Council Submission to Department of Planning Modification Application to Casuarina Town Centre Concept Plan Approval MP06_0258 MOD 15 (Council reference DA10/0222.30) at Lot 51 DP 1264557; No. 10 Grand Parade CASUARINA

Assessment of Modifications Proposed as Part of this Application

Figure 1: Ground Floor Plan with Pedestrian Entrances Identified

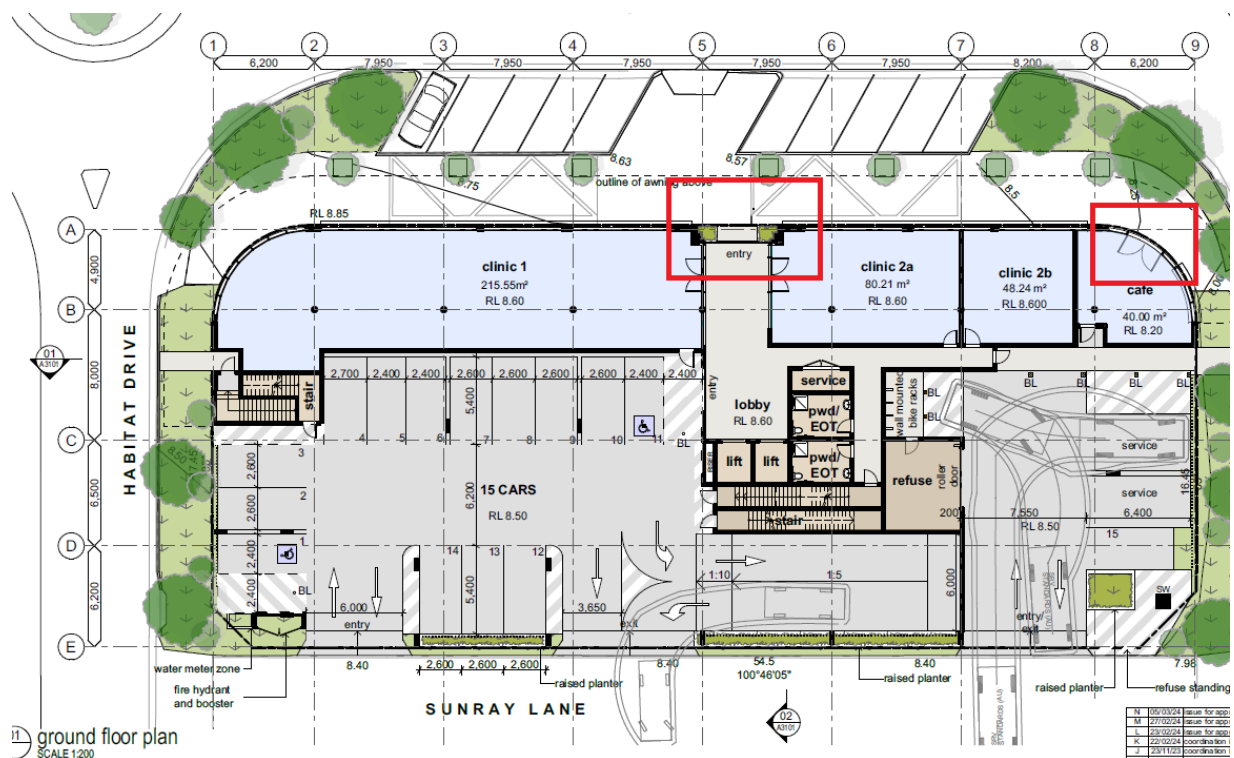
The purpose of this condition is to ensure an active street frontage to Grand Parade and the submitted design is not considered to achieve this, with two pedestrian entrances to the entire street frontage, being one to the proposed café and one to the medical centre, as demonstrated below;

This is not considered to activate the street frontage and it is recommended that an updated development design proposal for this site should incorporate additional direct pedestrian access points to all ground level tenancies in order to achieve the intent of this condition. Some concern would also be raised with respect to whether medical suites to the ground floor would deliver the intended activated retail/commercial uses across this prominent street frontage.

essentially a 'closed' elevation for a substantial proportion of this street frontage would be to the detriment of the desired active street edge. As a minimum some of the ground floor tenancies should be identified for more active uses with shop fronts which open onto the street. This should preferably be a combination of retail / food and beverage uses. The small 40sqm cafe located on the eastern corner is considered insufficient.'

Figure 2: Extent of Fourth Storey Proposed

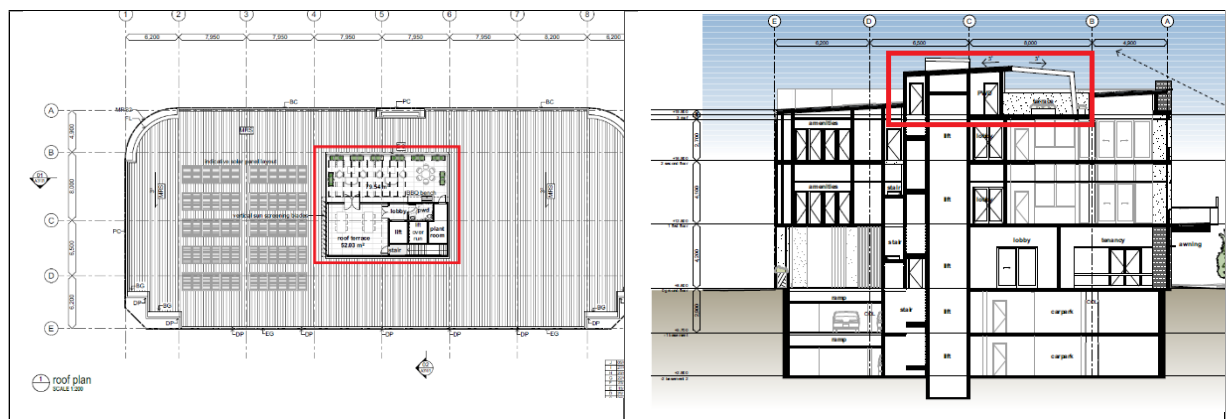
Under MP06_0258 the approved documentation identifies a three storey building envelope for this site. The submitted plans indicate development to the roof terrace level which would partially constitute a fourth storey and the proposal would therefore be in contravention of the existing control, resulting in the modification request to allow this fourth storey element.

The extent of rooftop terrace/fourth storey component is identified in figure 2 below;

'While clearly exceeding the three-storey height limit (and 13.6m height typically associated with E1 Local Centre locations, it is recognised the roof top terrace would provide the occupants with a valuable area of outdoor space, and would largely be undetectable from the street edge given it is set in substantially from the building edges. Based on the submitted sunshade diagrams, the shadow from this roof top element would only fall across the roof of the level below and wouldn't further contribute to the overshadowing of the residential properties to the immediate south than would result from the proposed three-storey building. As such from a design perspective, no objection is raised to the roof top terrace and shade structure.'

Figure 3: Extent of Development Exceeding 13.6m (shown red dashed line)

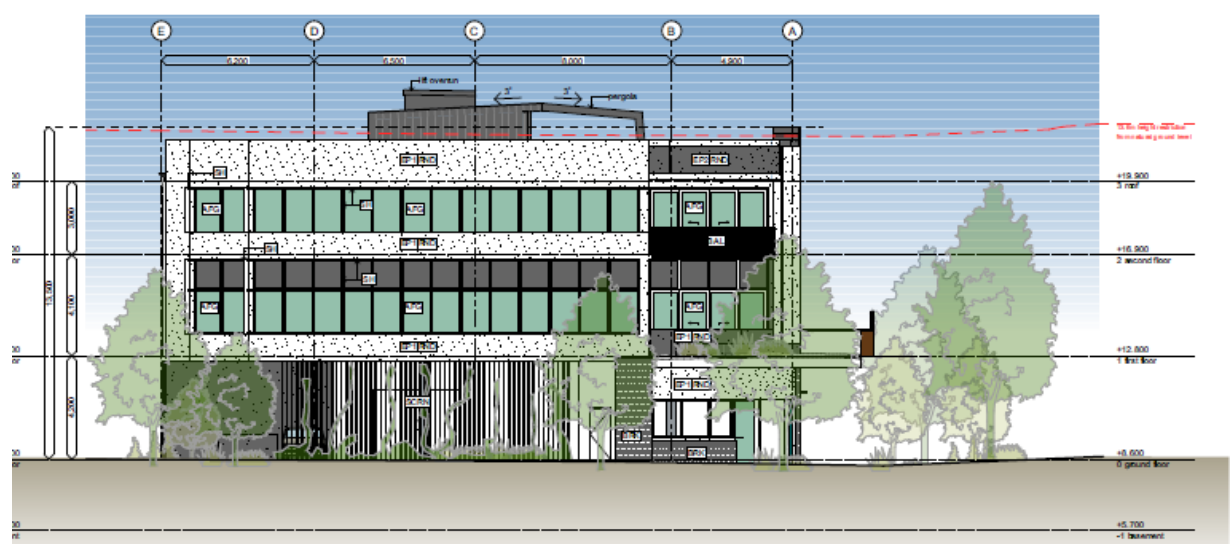
Under Tweed Local Environmental Plan 2014 the subject site is currently subject to the 13.6m Building Height Control. This would typically enable a four storey development, however it is noted that the submitted plans identify that the proposal would also exceed this 13.6m height limit (maximum of approx. 15.4m proposed), as demonstrated in figures 3 and 4 below;

In order for Council staff to typically support a variation to building height to the Tweed LEP controls (i.e. an increase to the 13.6m building height for the site), a Clause 4.6 variation would be required for consideration of potential impacts arising from this. Given the extent of variation exhibited here (i.e. exceeding 10%), this would need to be endorsed by elected Council.

In absence of following this process, Council staff are not in a position to definitively support the building height demonstrated on the submitted material. However, there would be no 'in principle' objection to a four storey development on site which adheres to the 13.6m height control contained in Tweed LEP 2014.

Where a partial fourth storey component also exceeds the 13.6m building height control for the site it would be recommended that this aspect of the modification be assessed similar to a Clause 4.6 variation and the applicant should submit corresponding information in order for this to be justified.
